IE Circular No. 79-13

REPLACEMENT OF DIESEL FIRE PUMP STARTING CONTACTORS

No. 74T 13-3A

New Components Available For Industrial Fire Pumps (NH-220-1F, N-855-F, NT-855-F1, and NT-855-F2 Series Engines)

Fig. 2 Magnetic Switch

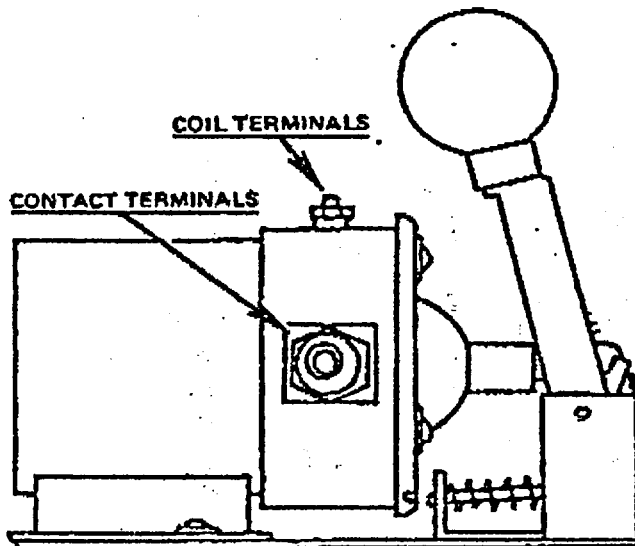
A new high pressure fuel pump shut-off valve Part No. 216930, Fig. 1, (optional field replacement) and magnetic switch Part No. 217588, Fig. 2, have been released to improve operation of inline 6 cylinder Industrial Fire Pump engines.

When replacing 118848 Magnetic Switch, 199573 DC Relay Contactor and 212461 Wiring Harness in the field they should be replaced with new design components.

Caution: When replacing 118848 Magnetic Switch and 199573 DC Relay Contactor with 217588 Magnetic Switch always check the controller relay for maximum current draw. The new 217588 Magnetic Switch has a 6 ampere draw whereas the old combination has approximately 3 amperes draw. Where necessary the controller relay can usually be replaced. Contact local controller representative.

A new wiring harness, AR-12498, which includes two (2) Part No. 217588 Magnetic Switches, wiring harness and mounting hardware must be used when making conversion.

Fig. 1. Wiring diagram

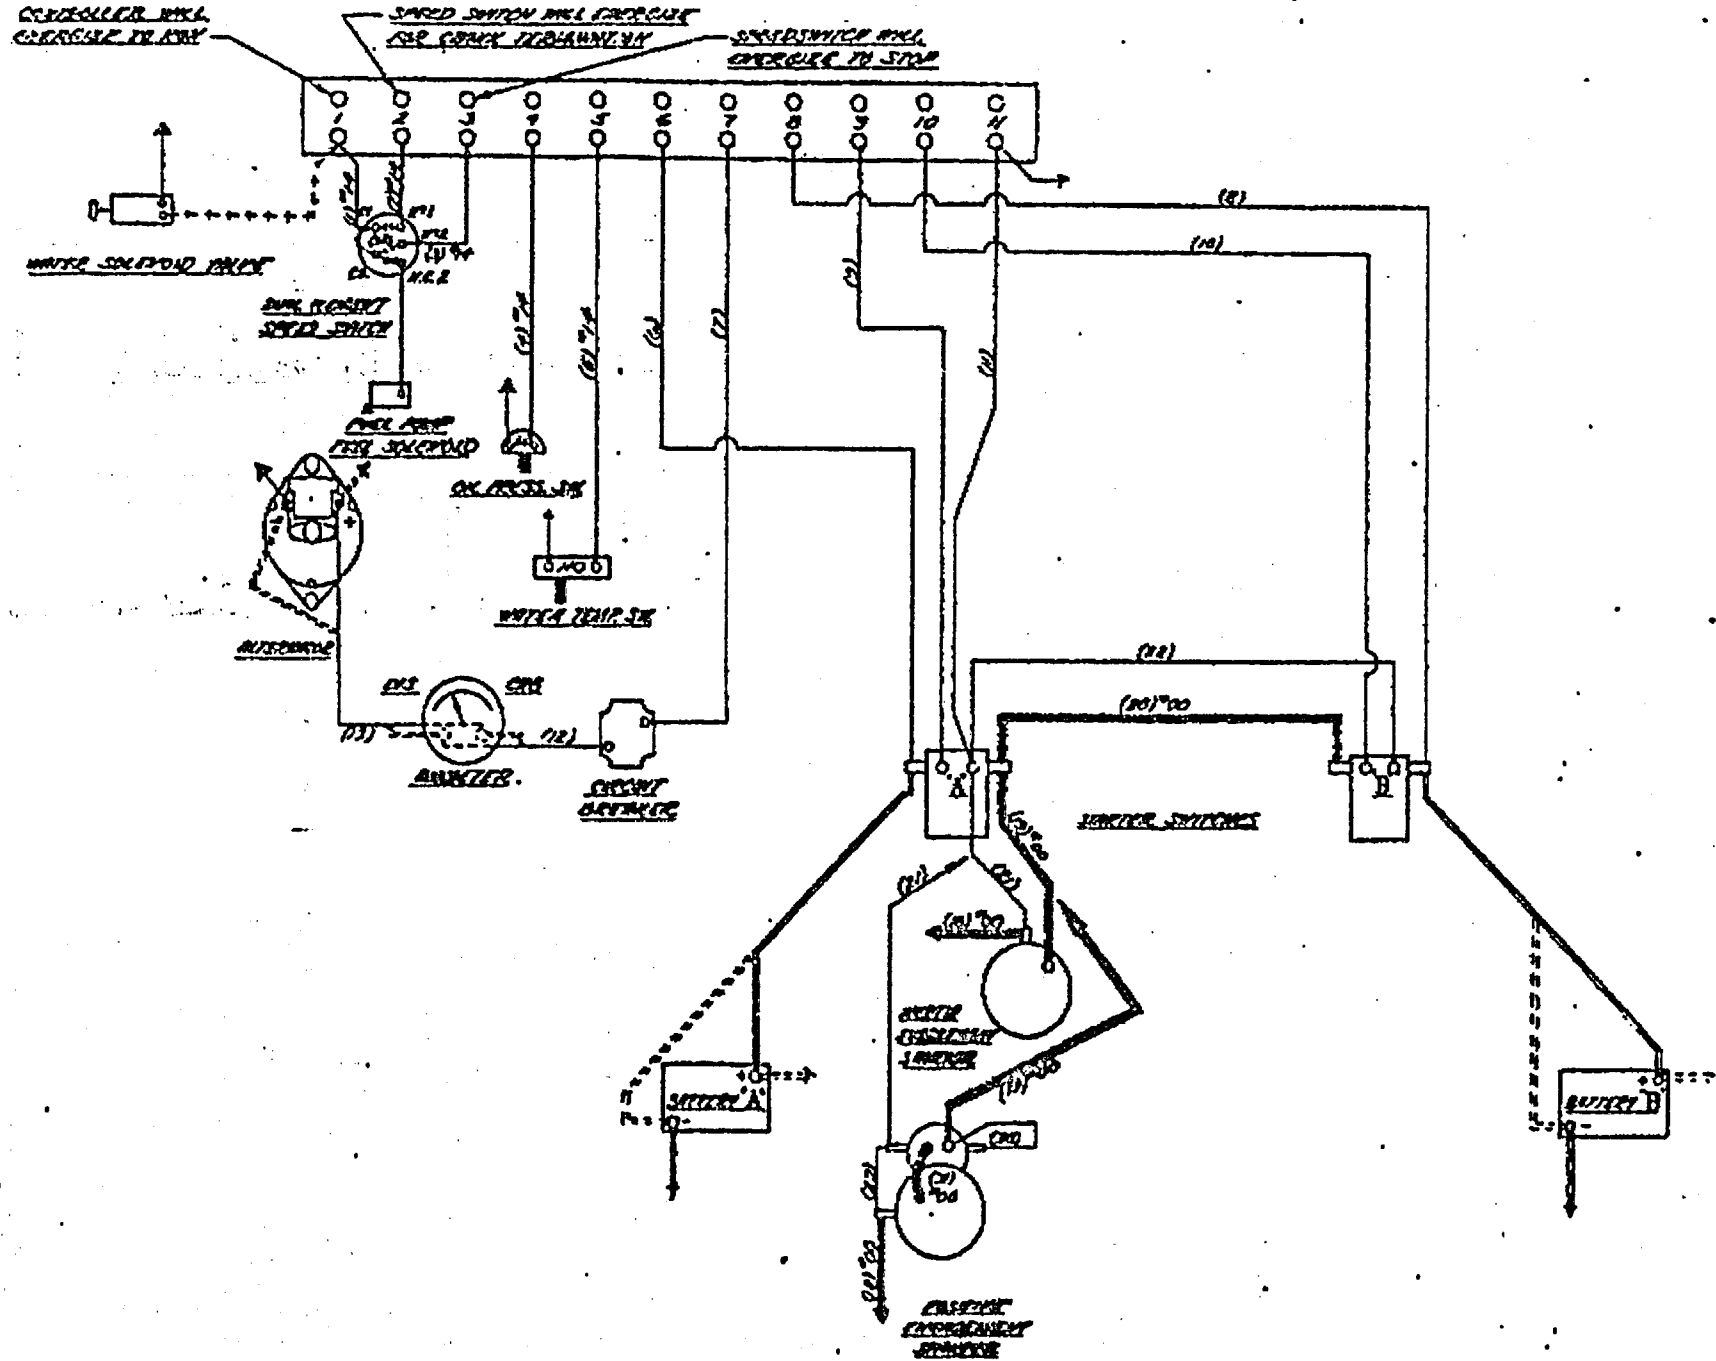
1. Remove wire harness connecting terminal block, ammeter, magnetic switches and voltage regulator or alternator.
2. Remove magnetic switch and DC relay.
3. Install 211088 Bracket to cylinder block above cranking motor.
4. Install two (2) 217588 Magnetic Switches opposite each other with manual start handles in "up" position.
5. Install new wiring harness as follows: Replace wires No. 2, 6, 8, 9, 10 and 11 on terminal block, No. 13 on ammeter and No's. 2 and 13 on voltage regulator. See wiring diagram, Fig. 3.
